# **CONNECTION ASSESSMENT & APPROVAL PROCESS**

*Project: Falconbridge No. 1 Substation: Provide Alternative Supply*

***CAA ID No. 2003-EX131***

*Date: 26th May 2003*

**DIAGRAM 1**

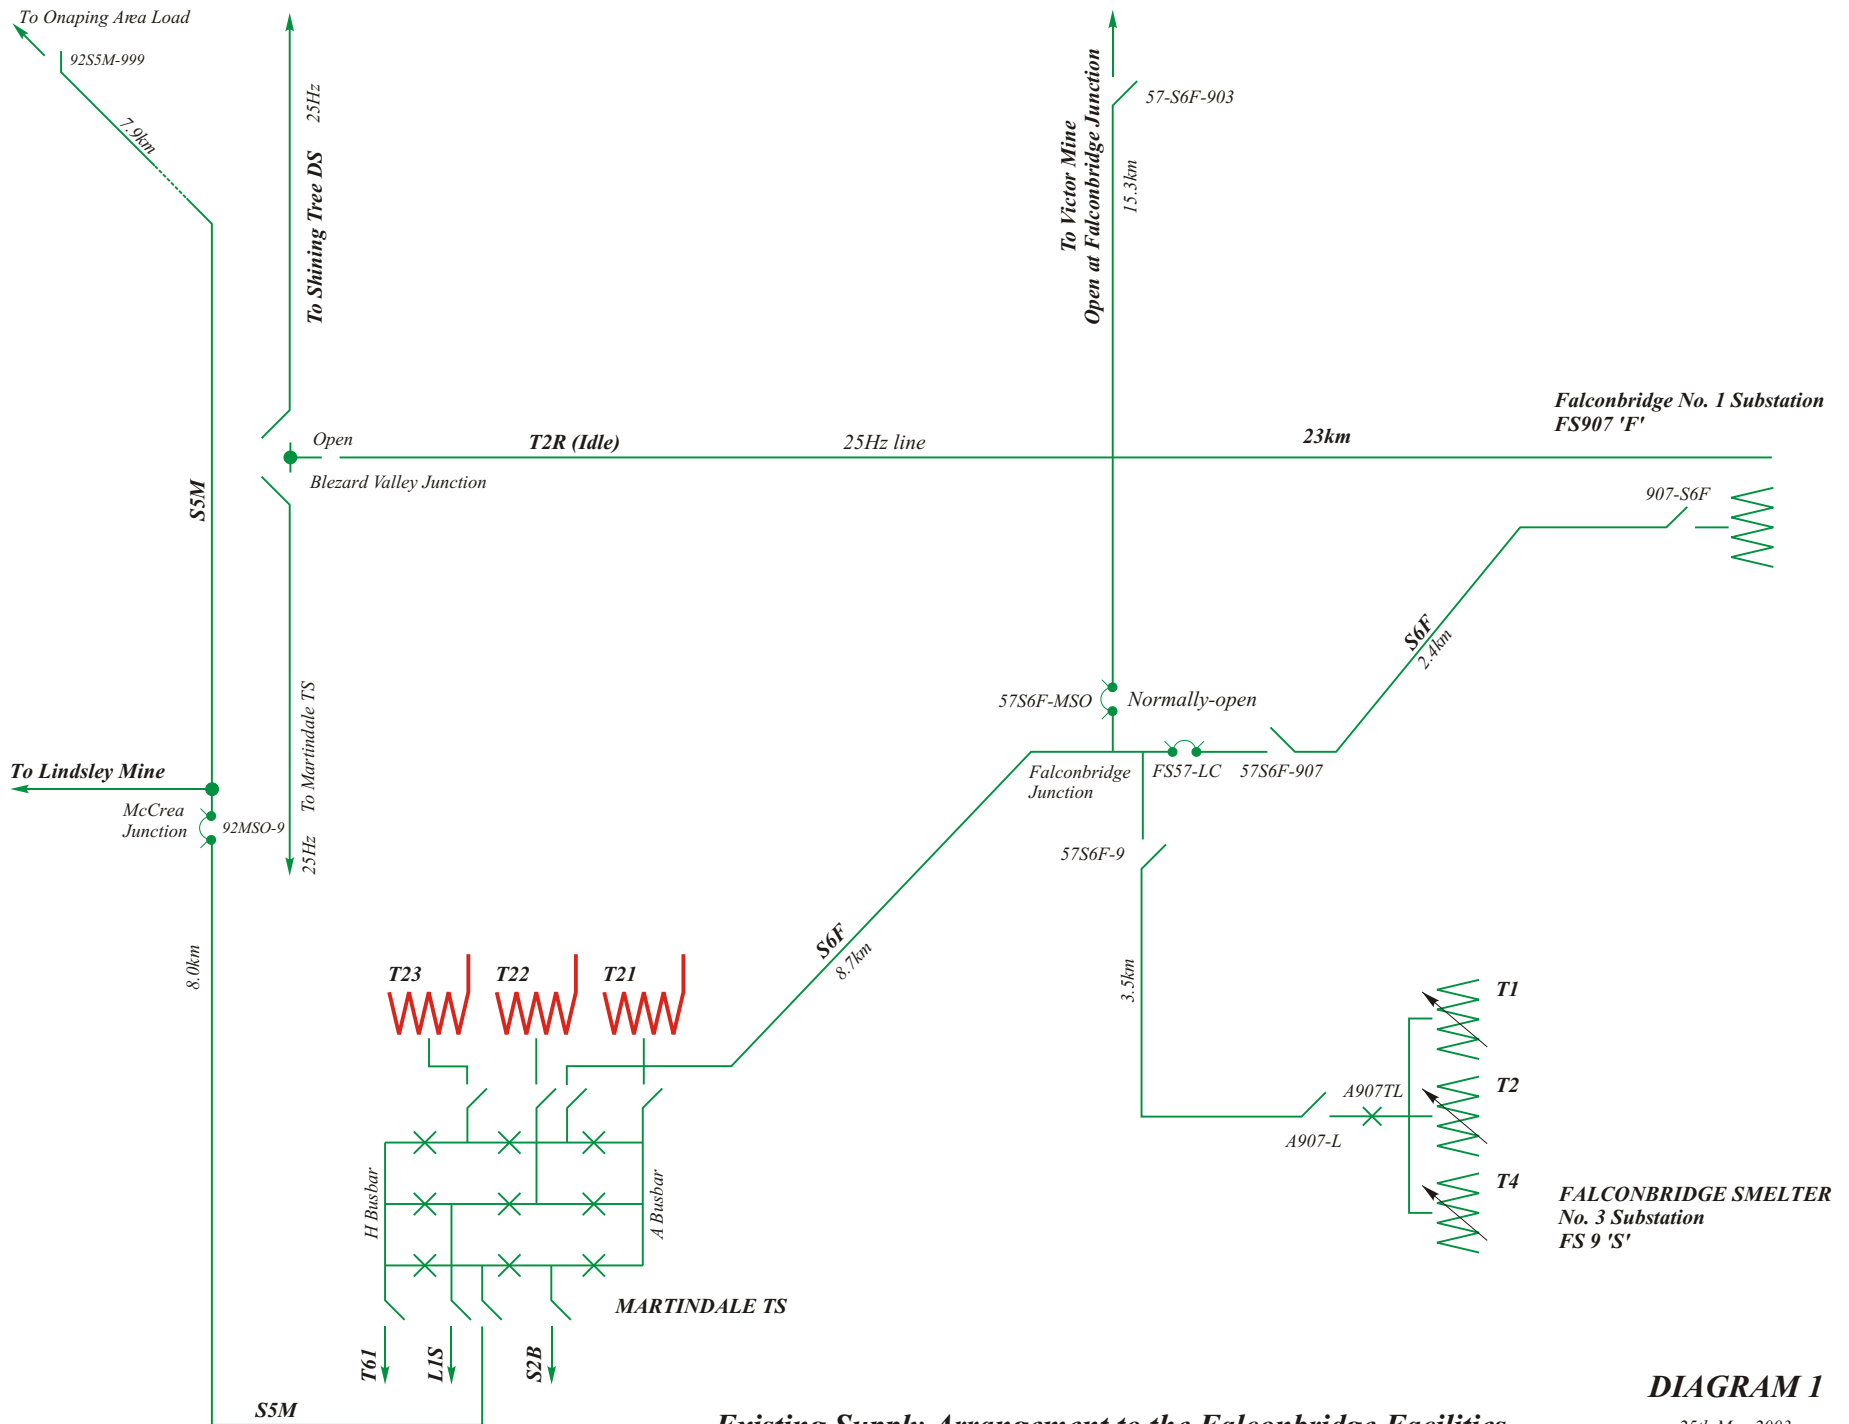
The 115kV circuit, S6F, supplies the following loads from Martindale TS, as shown in Diagram 1:

- Falconbridge No.1 Substation
- Falconbridge Smelter No. 3 Substation, and
- Inco Victor Mine TS (although the 15km line to this site is presently idle).

**DIAGRAM 2**

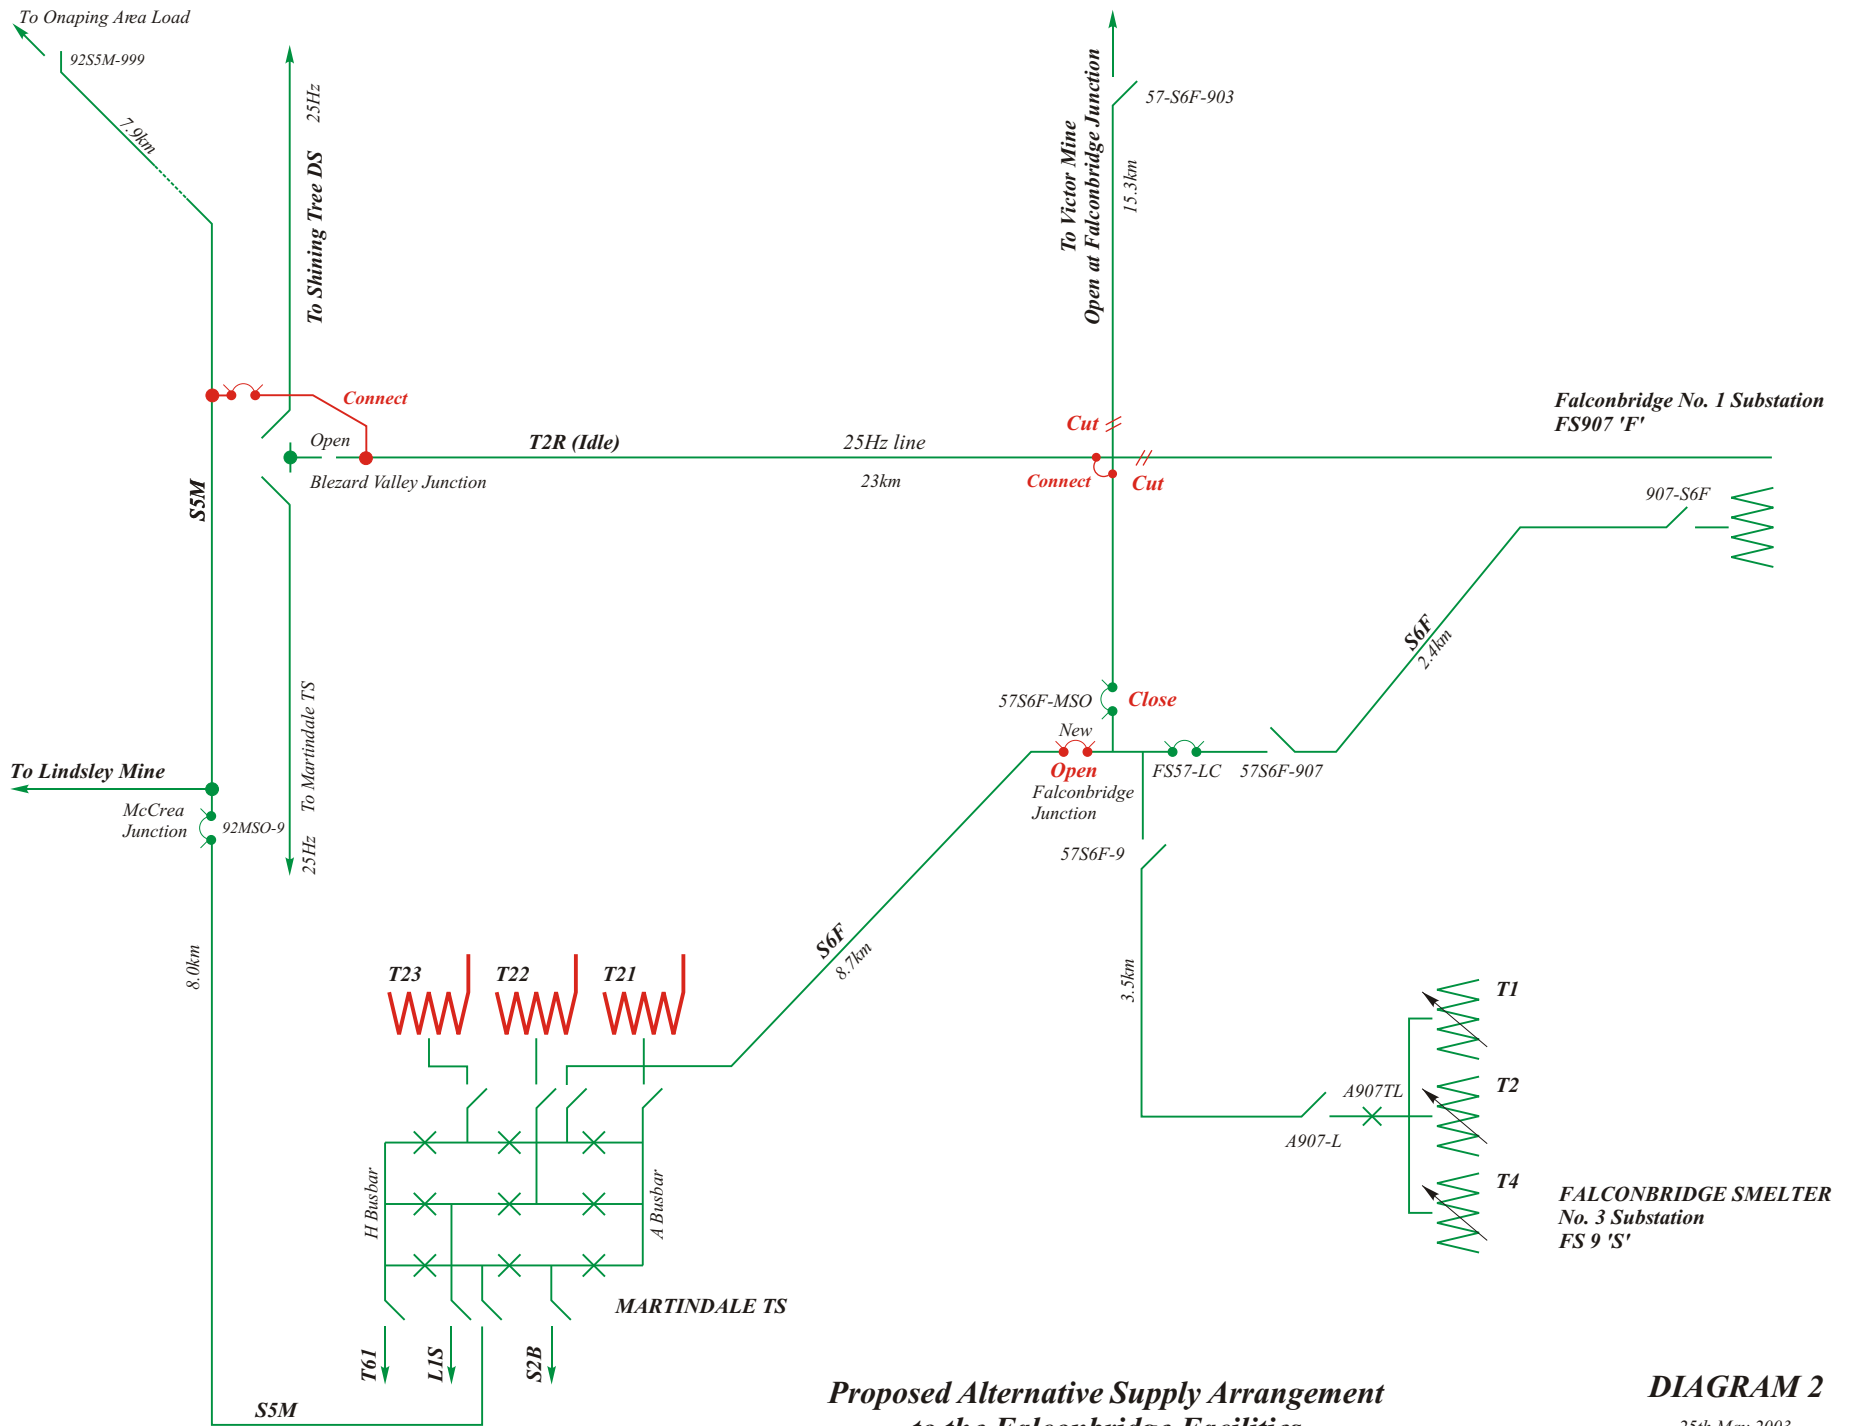
Diagram 2 shows the arrangement that it is proposed to implement to provide an alternative supply to Falconbridge No. 1 Substation.

- At Blezard Valley Junction -
  - Install a new connection between circuit S5M and the idle section of the 25Hz circuit T2R. This connection is to include a new set of MSOs.
- At the location where the idle section of the 25Hz circuit T2R from Blezard Valley Junction to Falconbridge No.1 Substation crosses the idle section of the 60Hz circuit S6F from Falconbridge Junction to the Inco Victor Mine -
  - Isolate the section of circuit T2R between Falconbridge No. 1 Substation and the Cross-Over
  - Isolate the section of circuit S6F between the Inco Victor Mine site and the Cross-Over
  - Interconnect the remaining sections of circuits S6F and T2R
- At Falconbridge Junction -
  - Restore the tapped connection to the Victor Mine on to circuit S6F
  - Install a new set of MSOs in the section of circuit S6F to Martindale TS
- Apply revised relay protection settings to circuit S5M

The section of circuit S5M between Martindale TS and Onaping Junction is equipped with 795kcmil conductors with a maximum conductor operating temperature of 93°C. Under summer conditions with an ambient temperature of 30°C and a wind speed of 4km/hr, the continuous rating of the line would be approximately 180MVA at 121kV.

The peak load that is presently supplied from circuit S5M is approximately 50MVA. During the 6-week slowdown at Falconbridge, the peak load on circuit S6F while this temporary connection is to be in operation, is expected to be less than 30MVA. Consequently, the continuous rating of circuit S5M will be more than adequate to accommodate the combined flow of around 80MVA.

Similarly, the idle sections of circuits T2R and S6F that are to be used for this connection, are each equipped with 211.6kcmil conductors with a maximum conductor operating temperature of 60°C. The corresponding continuous rating of approximately 42MVA would also be adequate to accommodate the reduced peak load that is to be supplied via the temporary connection.

The proposed temporary connection from circuit S5M to the Falconbridge No. 1 & Falconbridge Smelter No. 3 Substations, using sections of the existing transmission lines in the area that are presently idle, will therefore have no adverse impact on the IMO controlled grid.

It is therefore recommended that a Notification of Approval of the Connection Proposal be issued.
